Response to consultation comments from Places Services
25/01947/FP: Full Planning Permission: Battery Energy Storage
System (BESS), ground mounted solar farm, associated
infrastructure, access and landscaping
Land South Of A507 Near Cumberlow Green, Clothall Road,
Clothall, Hertfordshire

Thank you for providing us with Place Services letter of 26 September 2025 ref 08372 setting out the Council's response regarding the Landscape and Visual Chapter of the ES.

Application ref: 25/01947/FP
Location: Land South Of A507 Near Cumberlow Green, Clothall Road, Clothall, Hertfordshire
Proposal/Description: Full Planning Permission: Battery Energy Storage System (BESS), ground mounted solar farm, associated infrastructure, access and landscaping.

Title:
Figure 13.1 Summer Viewpoints

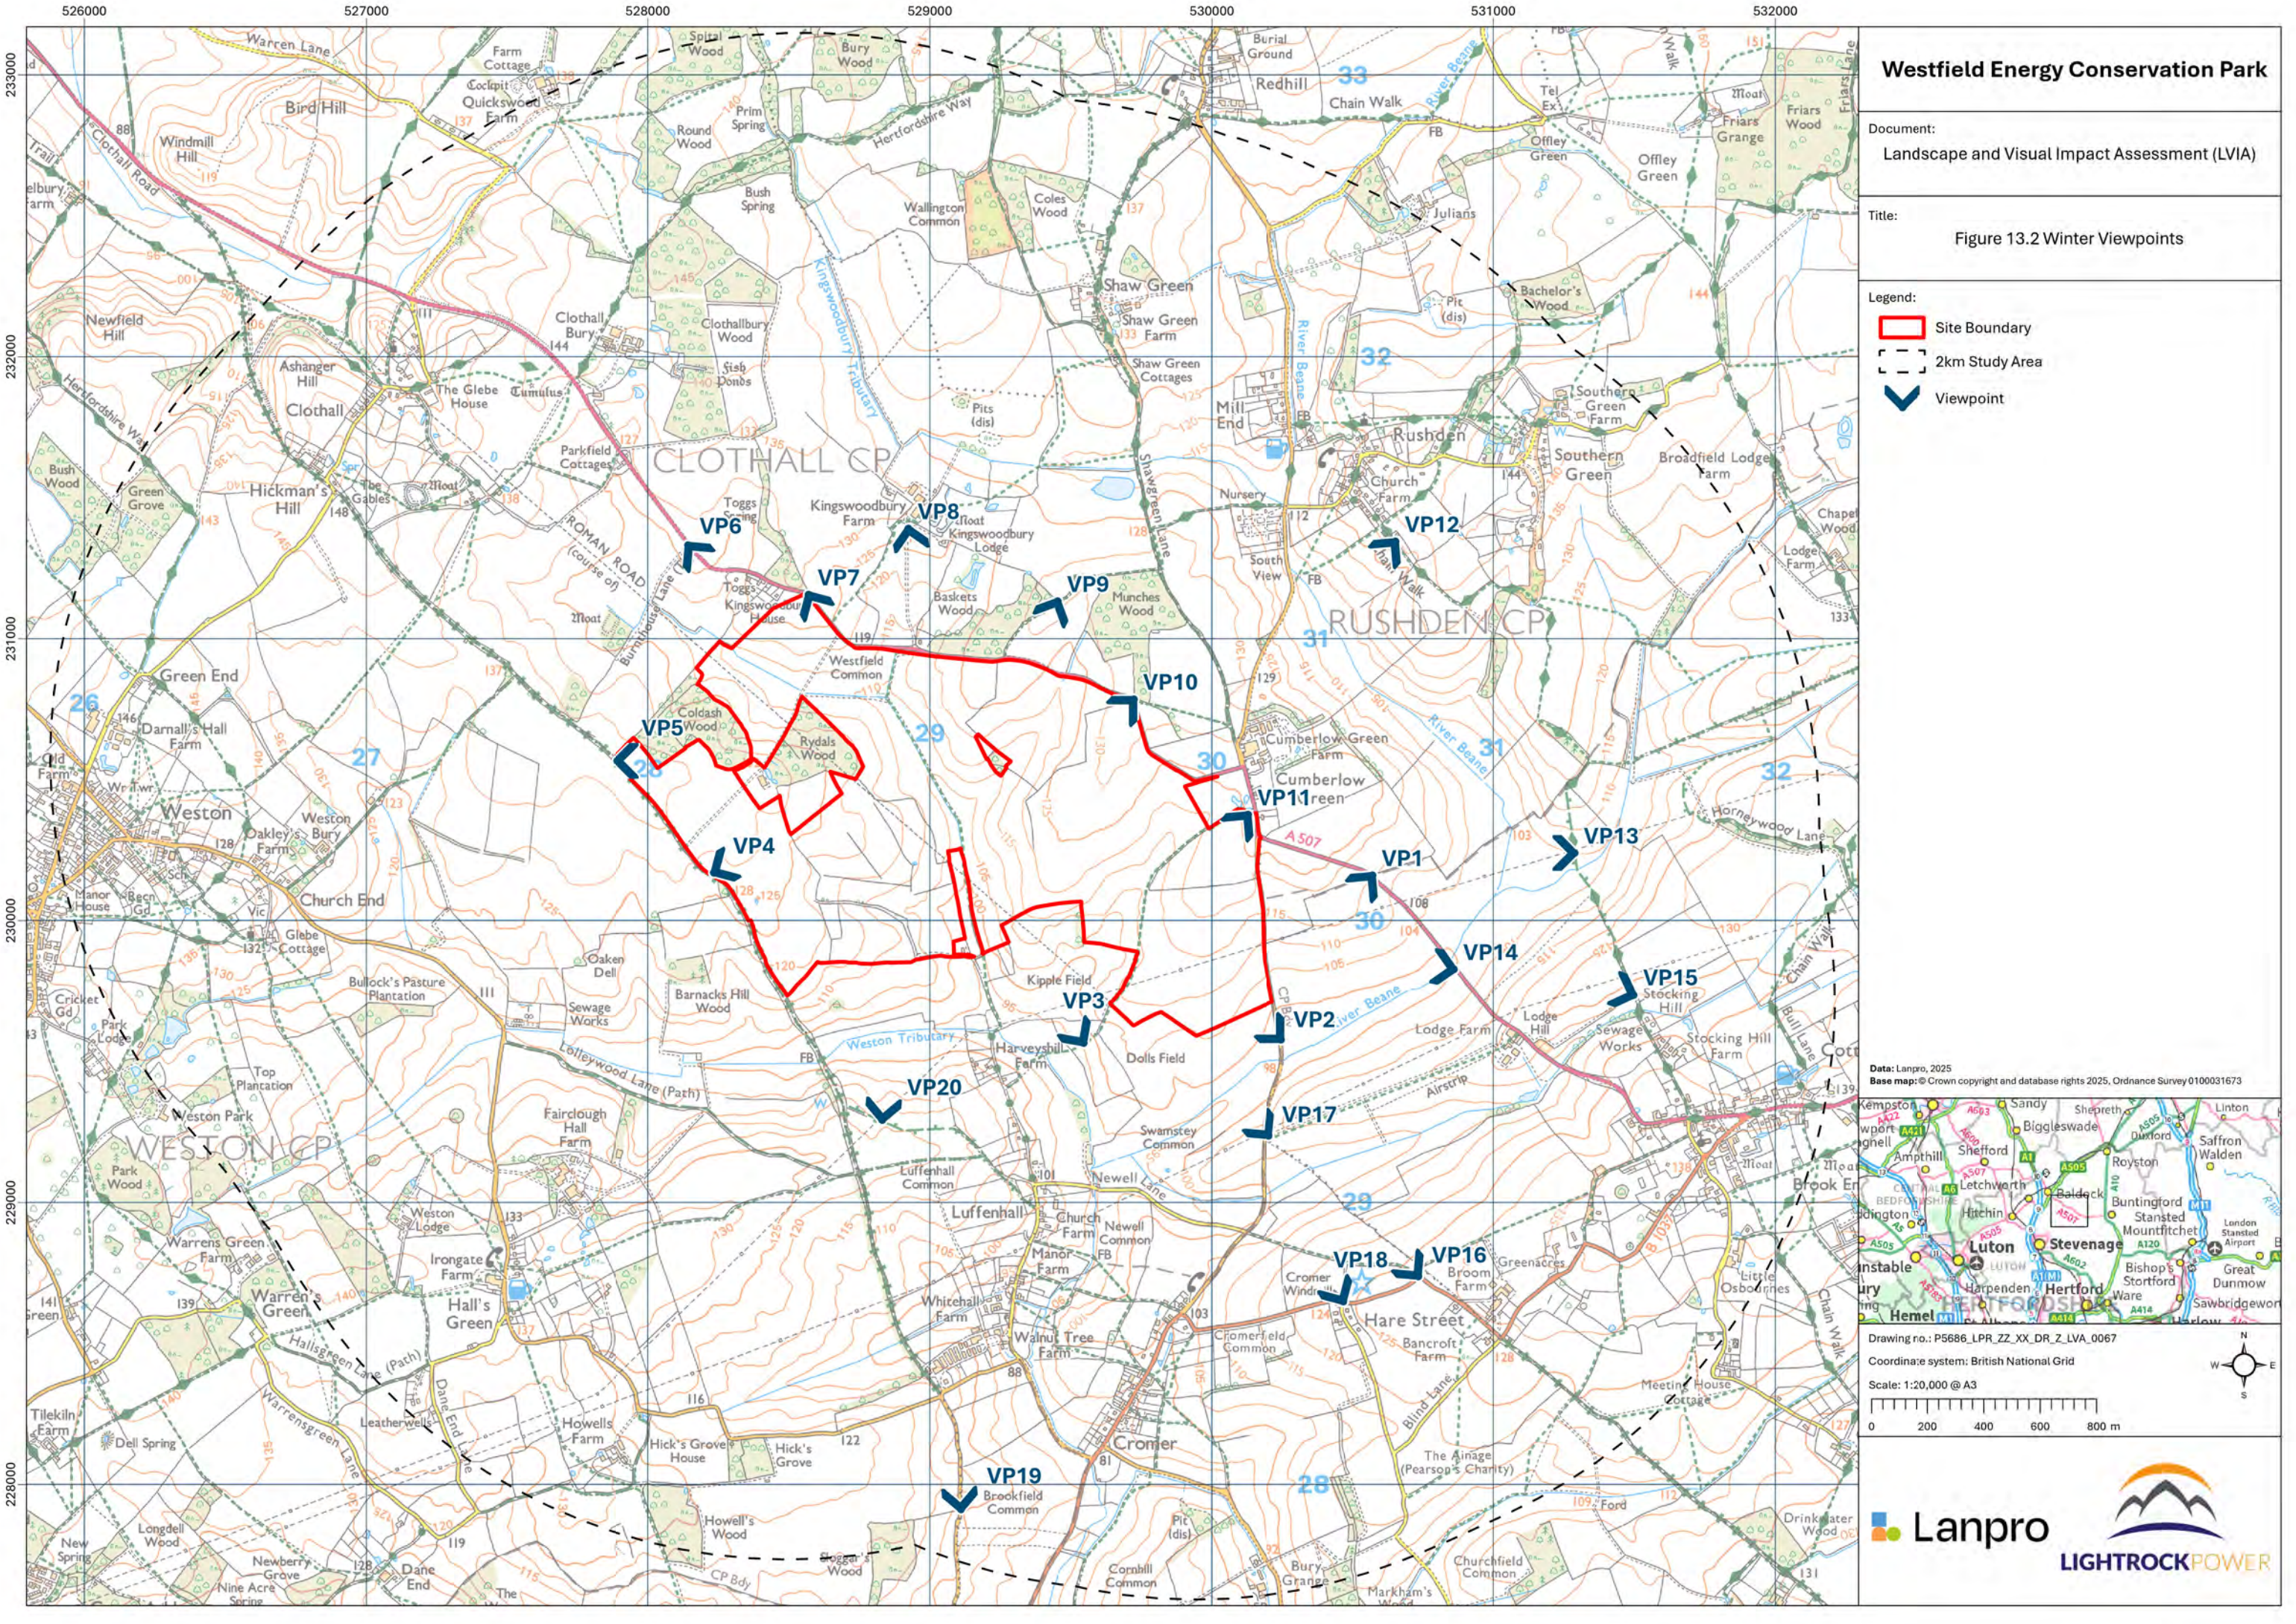
We previously provided commentary on the Viewpoint Locations through Pre-Application Consultation. The submitted Viewpoint Locations (Figure 13.3 – Summer) have included revisions to the locations and additional viewpoints to reflect some of our previous comments. Where additional viewpoints have not been included based on our advice, these are for viewpoints representing mid- to long-distance views. However additional mid- to long-distance viewpoints have not been included. And our previous request for these remains extant

- BOAT Clothall BY 012 (Viewpoint 5): Long-distance views of the rolling arable countryside across Beane Valley are a notable feature within this landscape and form part of the Weston Golden Jubilee Walk. We have concerns that the proposed PV panels, fencing and Native Species Shrub Planting would obstruct views from the BOAT across the countryside and detract from the experience of users along this PRow.

- A507 (Viewpoint 7): Expansive and characteristic views are obtained from the A507 driving south-east. We have some concerns regarding the visual impact of Field 3 from this view, as it is located centrally within the arable countryside view.
- Internal Viewpoints:
 - PRow Clothall 019 (Viewpoint 24)
 - PRow Clothall 020 (Viewpoint 22)
- Restricted Byway Clothall 021 (Viewpoint 20): The solar farm comprises a wide extent of the Beane Valley and this can be viewed from BY Clothall 20 to the south. A visualisation from this location would demonstrate the extent of the view that would be occupied by solar development.

We are happy to provide the five visualisations as requested (locations shown on the attached Viewpoint plans), namely:

- Viewpoint 5: BOAT Clothall BY012:
 - o Existing Winter Photography
 - o Photomontage, Winter Year 1
- Viewpoint 5a: BOAT Clothall BY012 (new viewpoint location as requested by LPA)
 - o Existing Summer Photography
 - o Photomontage Summer Year 15
- Viewpoint 7: A507:
 - o Existing Winter Photography
 - o Photomontage Winter Year 1

- Viewpoint 7a: A507: (new viewpoint location as requested by LPA)
 - o Existing Summer Photography
 - o Photomontage Summer Year 15
- Viewpoint 20: Restricted Byway HD|Clothall|021
 - o Existing Winter Photography
 - o Photomontage Winter Year 1
 - o Existing Summer Photography
 - o Photomontage Summer Year 15
- Viewpoint 22: Footpath HD|Clothall|020 (no existing winter photography available)
 - o Existing Summer Photography
 - o Photomontage Summer Year 15
- Viewpoint 24: Footpath HD|Clothall|019 (no existing winter photography available)
 - o Existing Summer Photography
 - o Photomontage Summer Year 15

However, this is fewer than the number of visualisations previously requested in your email as attached, and your current consultation letter also suggests that further viewpoints may still be required. Before we commission the visualisations, please could you confirm a final agreed list of required viewpoints.
